Reference: Engineering Services
Altis Serenity Amenity Building
Project No.: 2401-010249_O

- 1) Assessment of unauthorized flange penetration in W8×21 moment frame column near base.

(Conduit Penetration Through Column Flange)

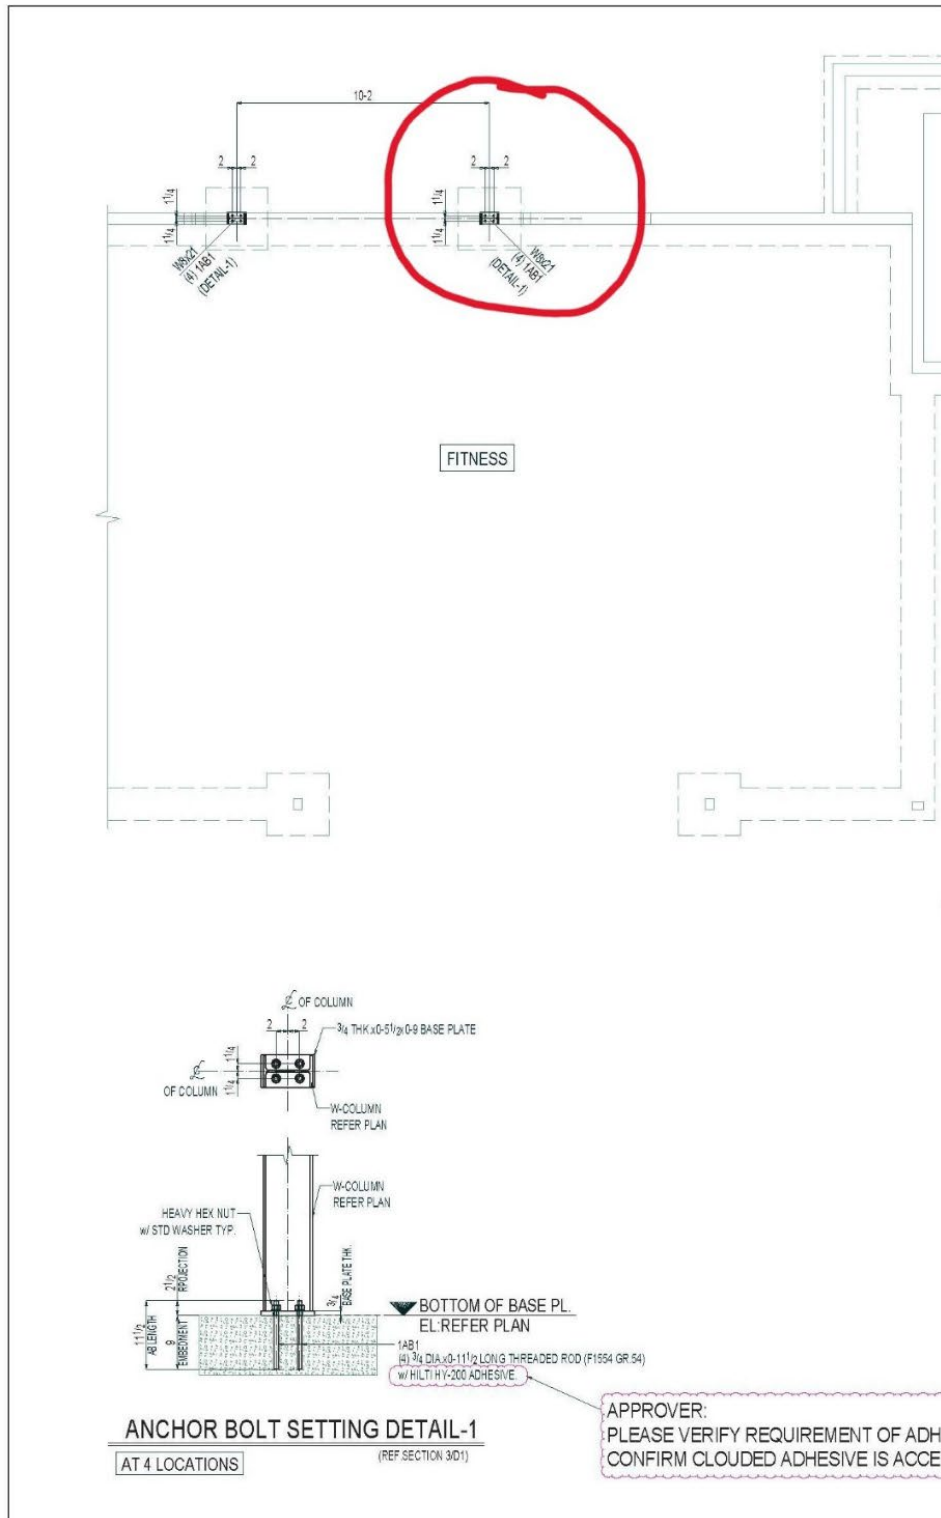
- 1) The W8×21 moment frame column, which includes a flange penetration, is adequate to support the anticipated loading conditions.
